From: [REDACTED]
To: [A30 Chiverton to Carland Cross](#)
Cc: [Jeremy Merrick](#)
Subject: Deadline 4 Submission from The Harvey Family, [REDACTED]
Date: 01 May 2019 15:21:06

We write in connection with the Applicant's responses to Deadline 3, specifically Document 8.9 Response to Hearing Action Points - ISH 2 on Draft DCO and the other documents mentioned therein.

Photograph showing the boundary (on the left-hand side of the photograph) between the Harvey family's wildflower meadow and the Pond Field.

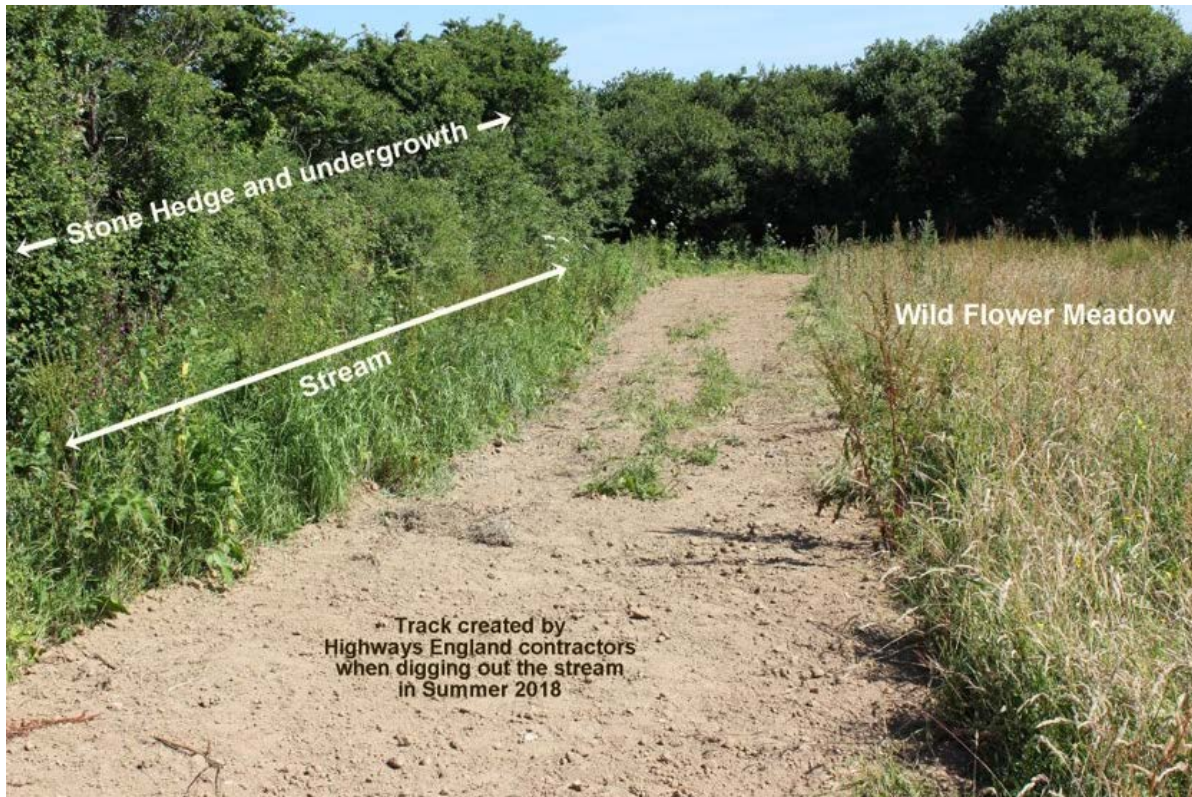
The stream is situated immediately adjacent to the boundary running between our wild flower meadow and with the attenuation pond field (Pond Field). The boundary comprises a substantial stone hedge with mature plantings (see photograph). Access between the two could only be achieved by wholesale destruction of at least part of this hedge. On sheet 6 of TREES AND HEDGEROWS TO BE REMOVED OR MANAGED APFP REGULATION 5(2)(O), there is no reference to this hedge being breached or removed, indeed virtually the entire hedge is enclosed by a black bordered box indicating, according to the key, that it contains VEGETATION TO BE RETAINED. This protection is reinforced on APP-195 6.3 ENVIRONMENTAL STATEMENT FIGURE 7.6 – ENVIRONMENTAL MASTERPLANS Sheet 15 of 20

where the red hatching extending over the stream and stone hedge highlights VEGETATION TO BE PROTECTED & RETAINED. The stream is also shown on the Environmental Masterplan as a watercourse and is again to be protected and retained. The Pond Field will have a vehicular access direct from the existing A30 across a wide highway verge. This will provide a very superior access.

Given that there is no physical connection between the Pond Field and our Wild Flower Meadow, and the applicants are not seeking to amend the protection that the hedge and vegetation enjoy, and since the applicants are not seeking to enlarge the DEVELOPMENT CONSENT ORDER BOUNDARY / LIMITS OF ORDER LAND we believe that the stream cannot be of any use in construction, useage, protection, inspection, maintenance of the attenuation pond, drainage, access or landscaping. We further believe that there would be no advantage whatsoever to the A30 Chiverton to Carland Cross improvement scheme in such permanent rights being acquired bt HE. Whilst we were, and remain willing to allow temporary usage of the stream while the attenuation pond is being built, we are not convinced that it is in the best interests of HE. We suspect the right was mooted by someone unfamiliar with the site and by reference to satellite imagery only.

We request that Schedule 5 of 3.1(D) The revised DRAFT DEVELOPMENT CONSENT ORDER be amended by deleting Plot 8/2c and the statement: "New right to construct, use, protect, inspect and maintain drainage attenuation pond no. 14, associated drainage facilities, access and landscaping". Colouring on SHEET 8 of 2.2(B) LAND PLANS (Deadline 3 version) of the stream should also be changed from blue (acquisition of permanent rights) to green (temporary acquisition), or removed altogether if the applicants agree that there is no benefit to them in acquiring the land temporarily.
